Amendments to the Drawings

Applicant respectfully requests acceptance of the following changes to the drawings shown in the attached marked up pages 1, 2 and 3, each which are marked as "Annotated Sheet". These changes are incorporated in the two (2) pages of formal drawings submitted herewith, each which are marked as "Replacement Sheet". These Replacement Sheets replace the Original four (4) sheets of non-formal drawings that were filed with the original application on September 8, 2003.

Application No.: 10/657,476
Filing Date: September 8, 2003

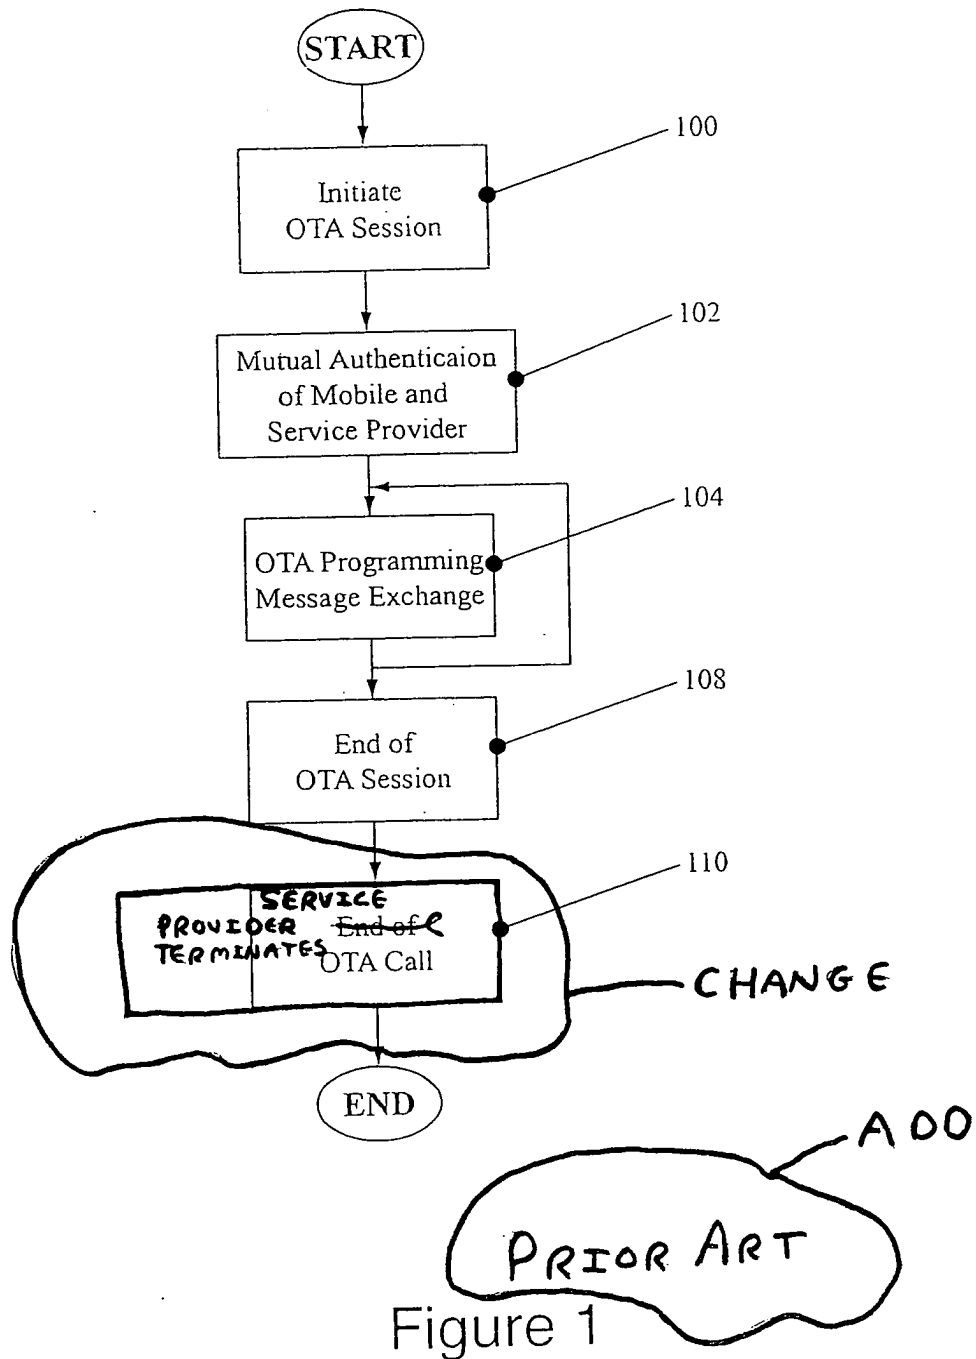
1. Amend Figure 1 block 10 as follows, this change is supported in paragraph [007] of the original specification, which states that "In step 110, the service provider then terminates the call by releasing the allocated communication channel":

Block 10 caption: ~~End of~~ Service Provider terminates OTA call

2. Amend Figure 1 by add "PRIOR ART" to the caption.

Figure 2

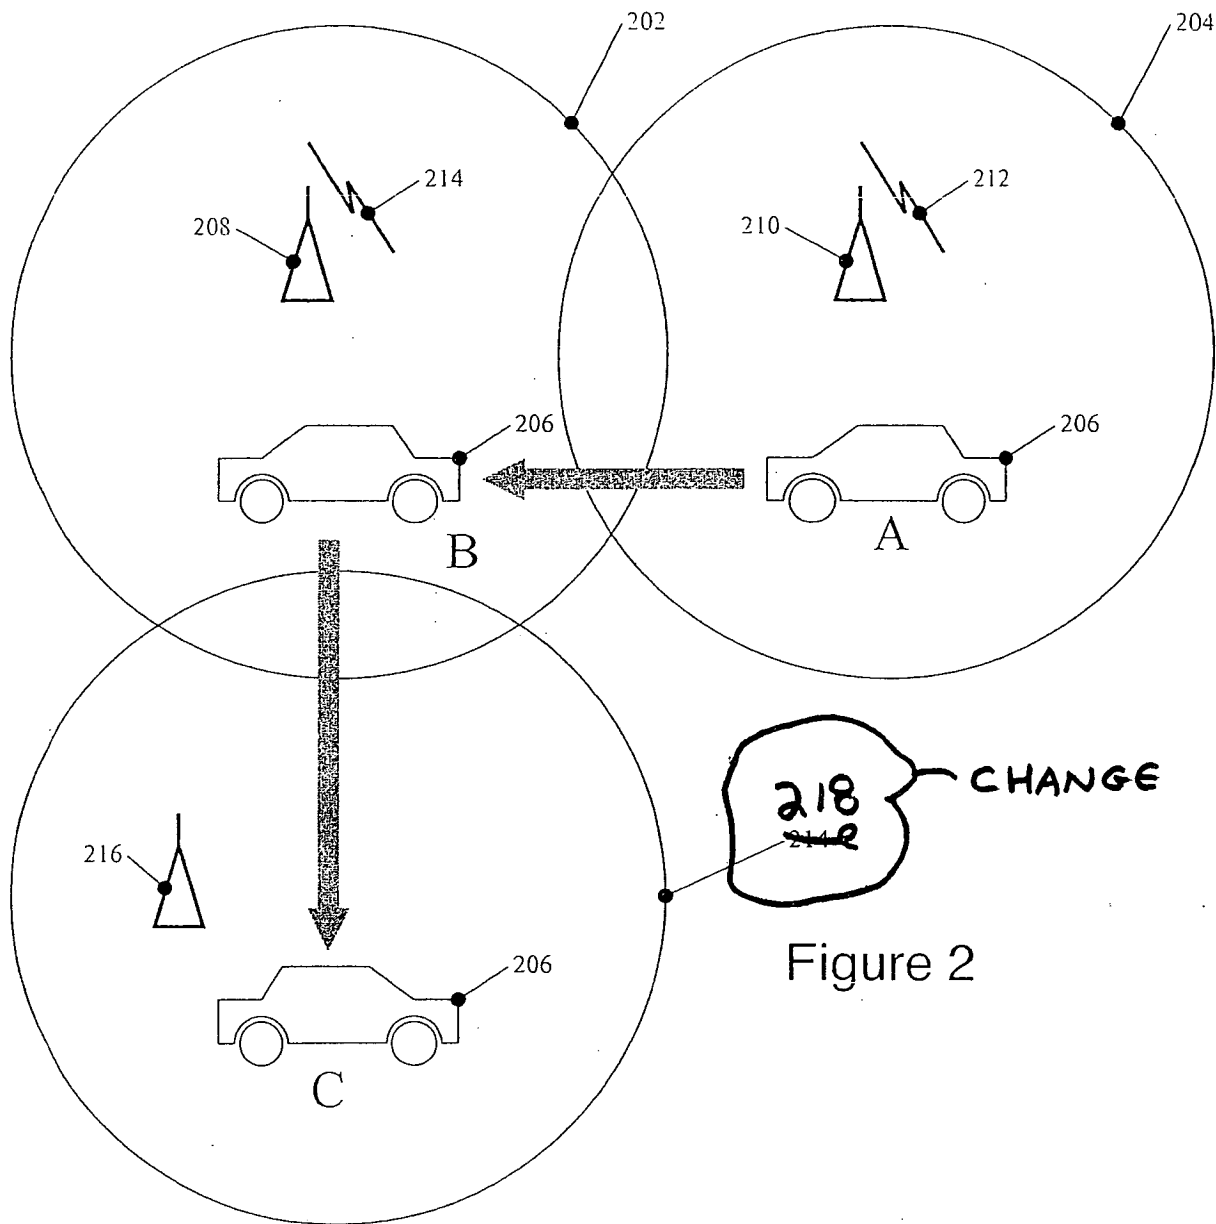
3. Amend Figure 2 by correcting the reference designator from "214" to --218-- as supported in paragraph [020] of the original specification.

Figure 3

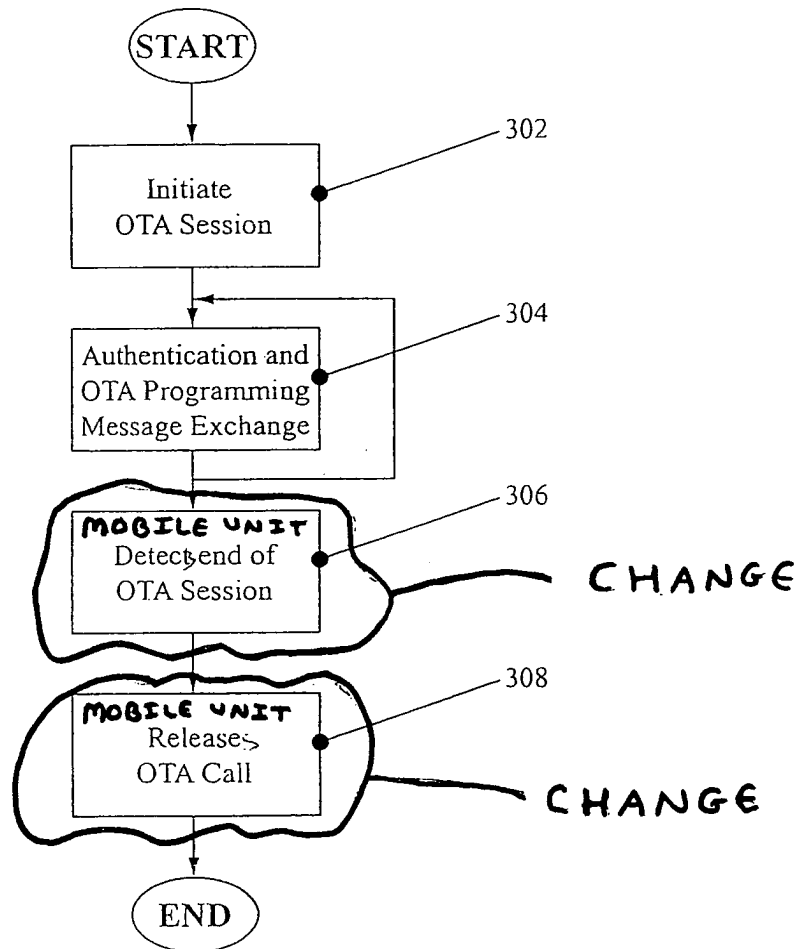
4. Amend Figure 3 blocks 306 and 308 as follows, these changes are supported in paragraph [022] of the original specification, which states that "Once all OTA messages are exchanged, and the OTA session has ended, the **mobile subscriber unit** can be configured to detect the end of the OTA session in step 306. The **mobile subscriber unit** can be configured to then release the OTA call in step 308, once the end of the OTA session is detected in step 306." (emphasis added)

Block 306 caption: ~~Detect~~ Mobile Unit detects end of OTA Session

Block 308 caption: ~~Release~~ Mobile Unit releases OTA Call
